Invitation for Bids for
Cutaway Buses (IFB 10-01)
Addendum No. 1
2/15/10

The following changes have been made to the specifications included in COAST IFB #10-01 dated February 1st, 2010.

Seating and floor plan update

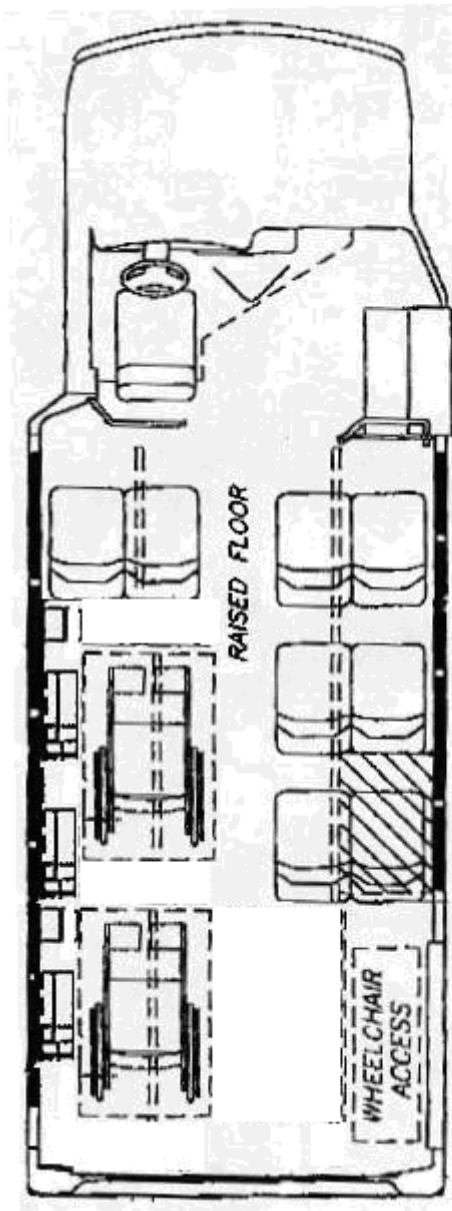
- 5.17.3 Clarification: refer to updated floor plan (attached) for seating arrangement.
- 5.17.5 Replace upholstery material “Holdsworth fabric style #YV/P23829” with “CMI Plush Orbit Blue #153”.

Note: three (3) sets of foldaway seats mounted on the left (driver's) side of the vehicle, with two (2) front-to-back wheelchair securement locations. The dimensions shown are not exact.
